Phase 2 Remedial Investigation Work Plan Addendum No. 3, Former Grumman Settling Ponds (Operable Unit 3, - Bethpage Community Park), Bethpage, New York.

July 13, 2006

SHEET TITLE
 PHASE 2 REMEDIAL INVESTIGATION
 SITE MARK OUTS

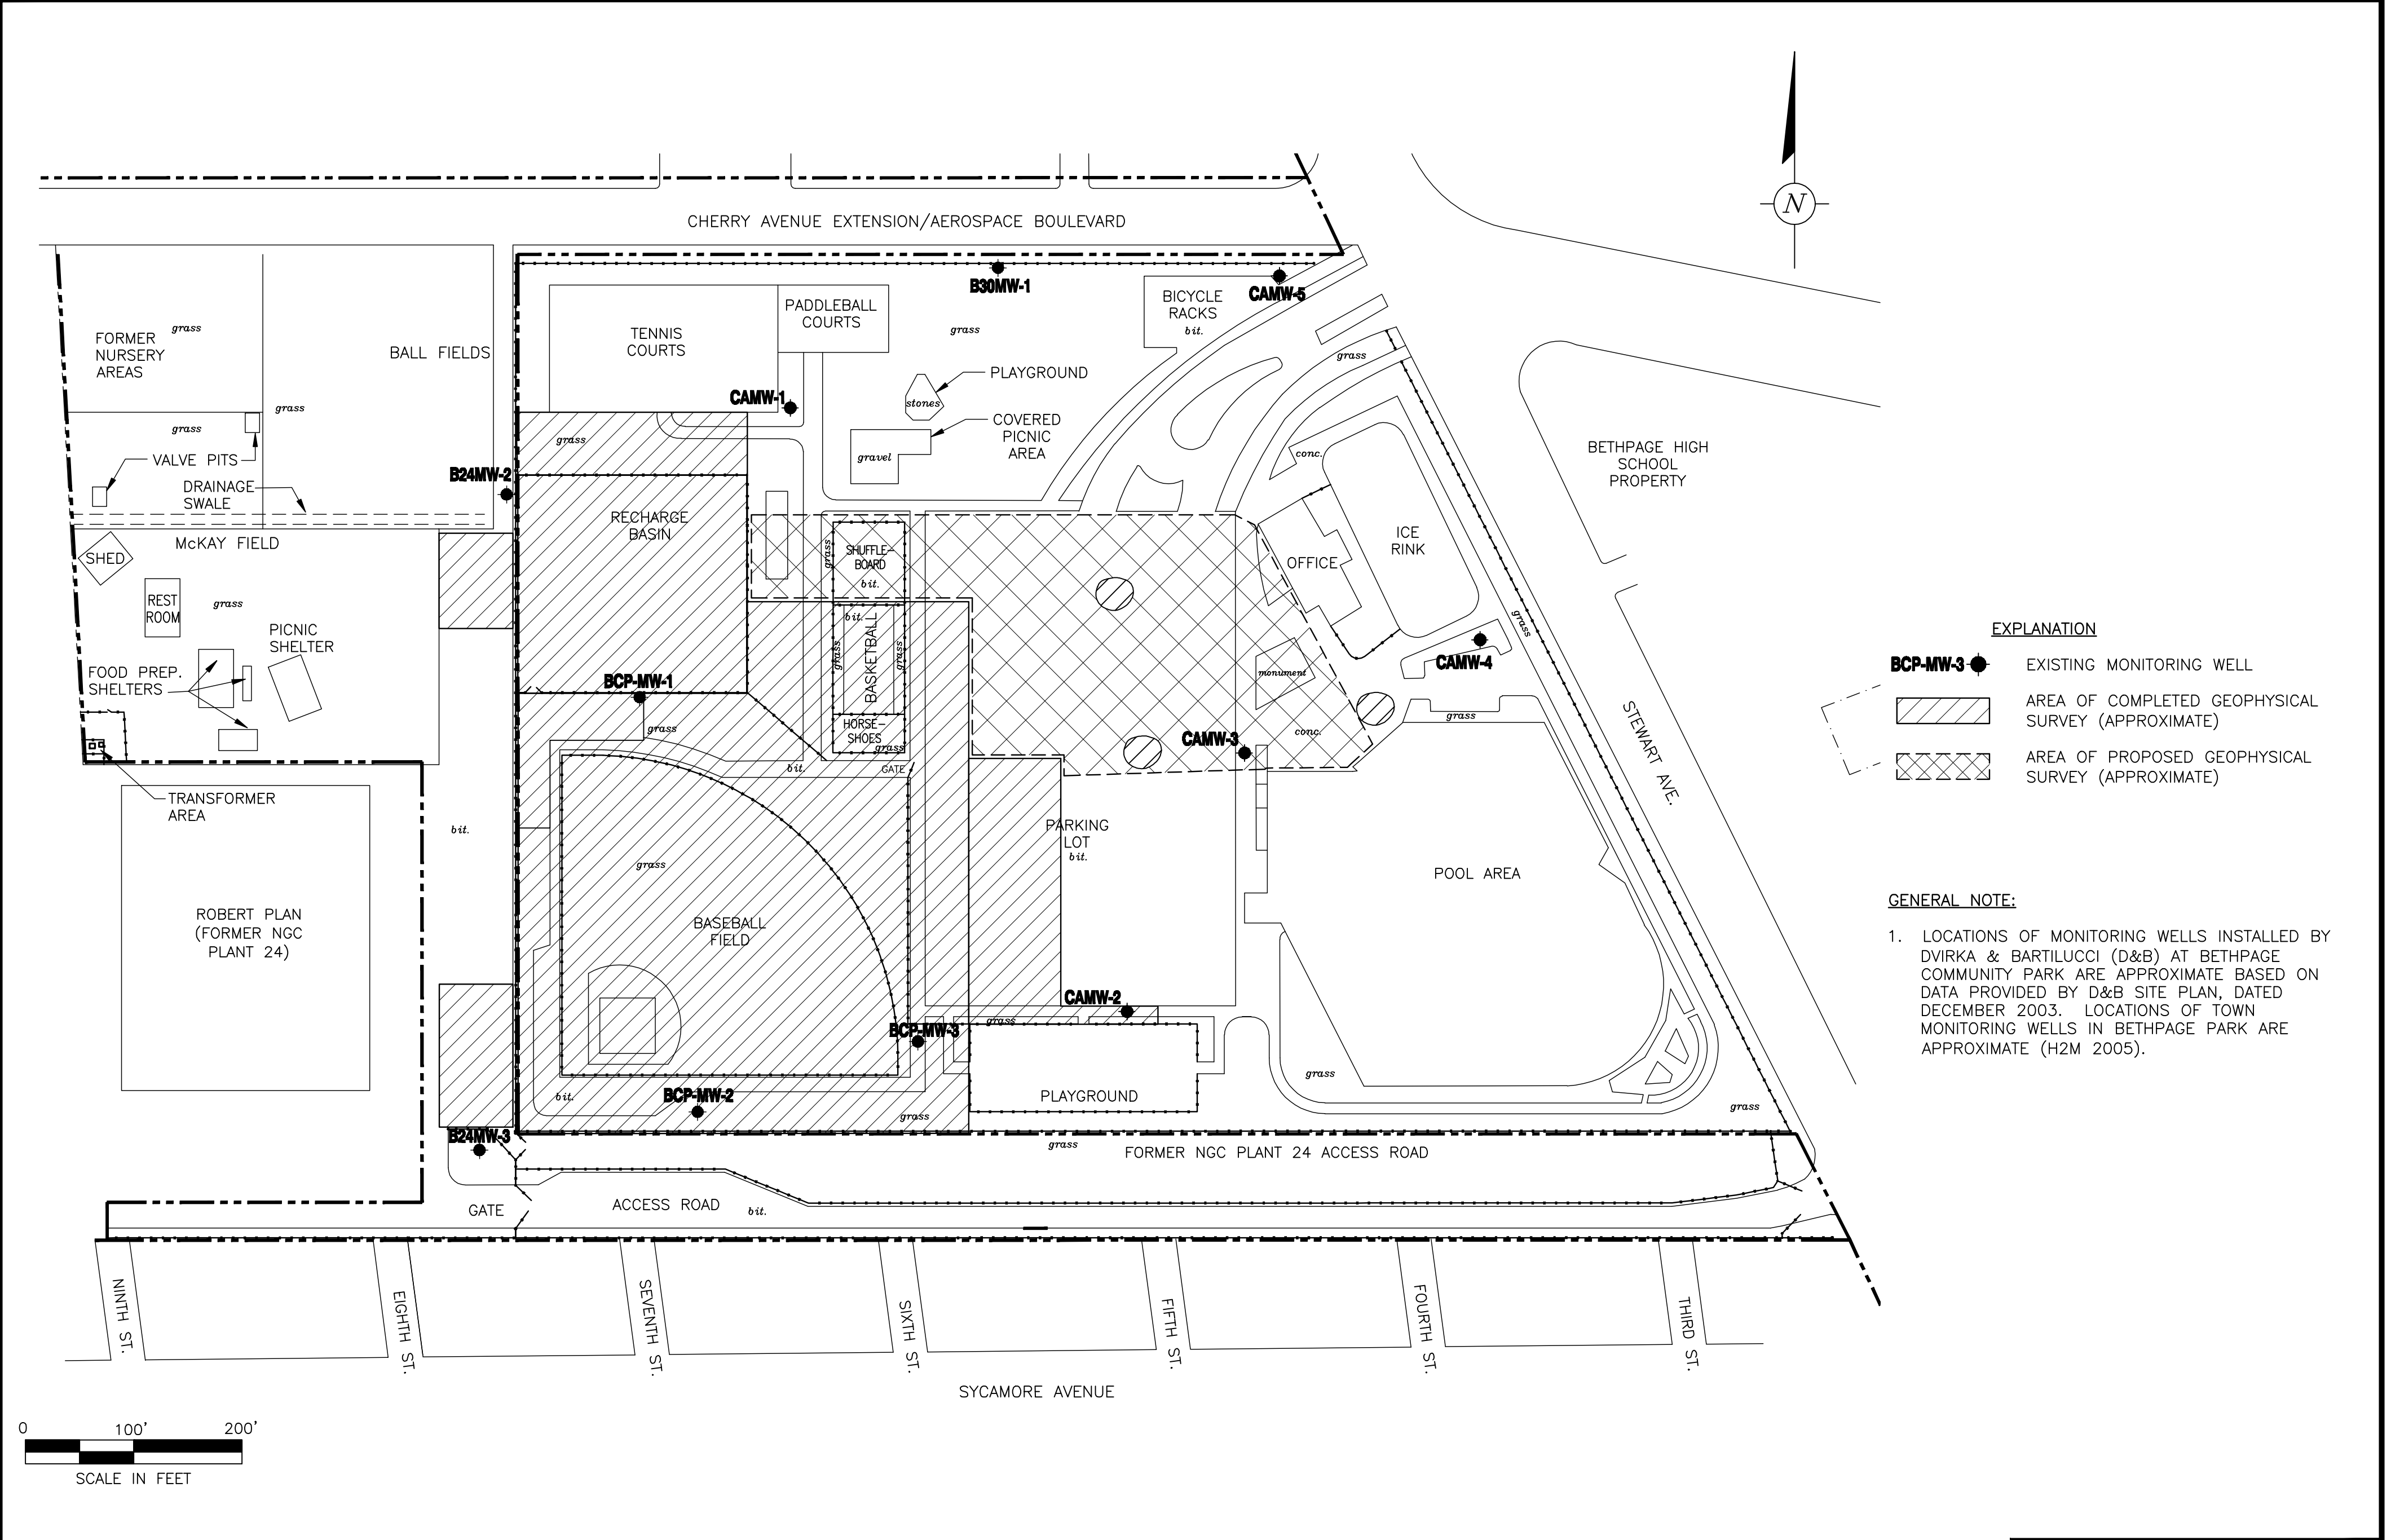
Figure 1 shows proposed subsurface utility mark-out area. Figure 2 depicts the alphanumeric grid and existing and proposed CPT/MIP borings.

Prior to drilling, subsurface utilities will be identified and marked out using an independent geophysical subcontractor. The CPT/MIP borings provide a rapid, continuous profile of soil type (through a variety of soil characteristics) and VOC concentrations. Collection of CPT/MIP data above, within, and below the low permeability zone is necessary to confirm the absence or presence of VOCs and obtain information on low permeability zone physical characteristics. This

SHEET TITLE
 SITE PLAN
 SHOWING PROPOSED AND
 COMPLETED CPT/MIP BORINGS

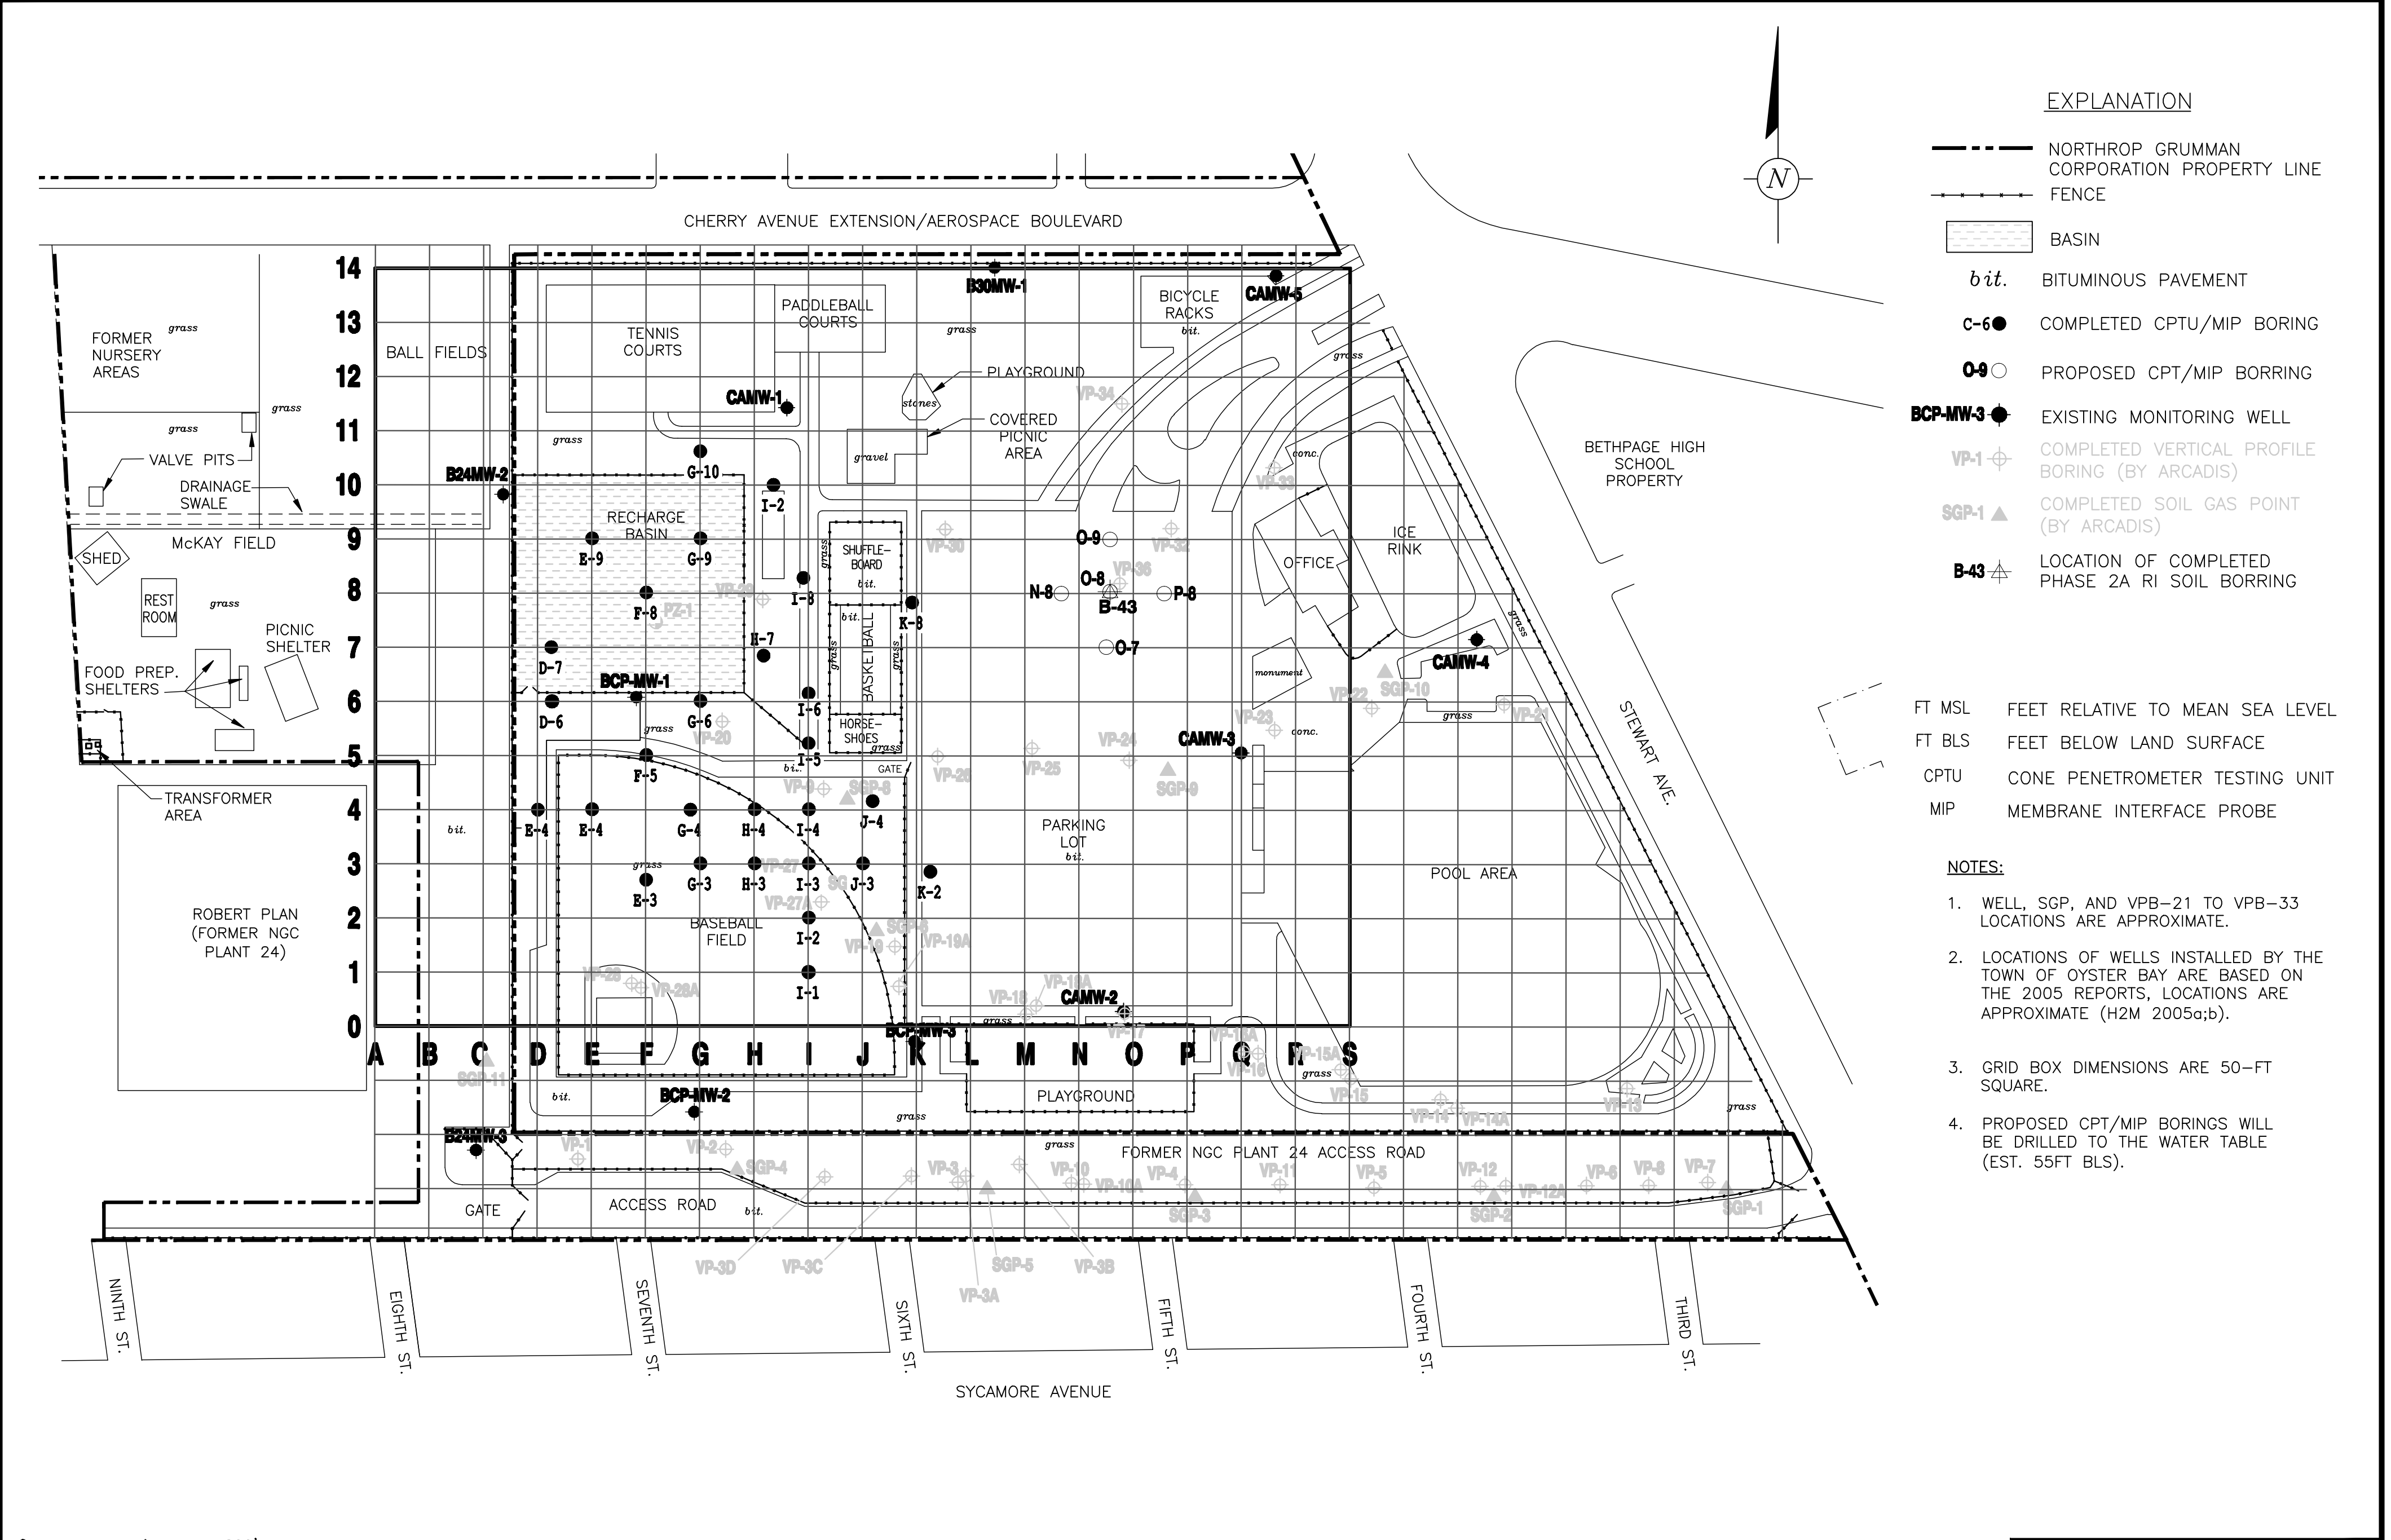
information will assist in the update of the CSM (i.e., determination of the vertical and horizontal extent of VOCs in soil and whether the physical characteristics of the low permeability zone are such that it could act as a source of groundwater VOCs). The CPT/MIP borings will be performed in a portion of the existing alphanumeric grid focused at and around the B-43 area. Initially, a total of five CPT/MIP borings are proposed (i.e., Borings N-8, O-7, O-8, O-9, and P-8). The final number of CPT/MIP borings will be determined in the field based on the results obtained. CPT/MIP borings will be advanced to the water table (approximately 55 ft bls) at each location; the total depth may be modified depending on field conditions and results obtained.
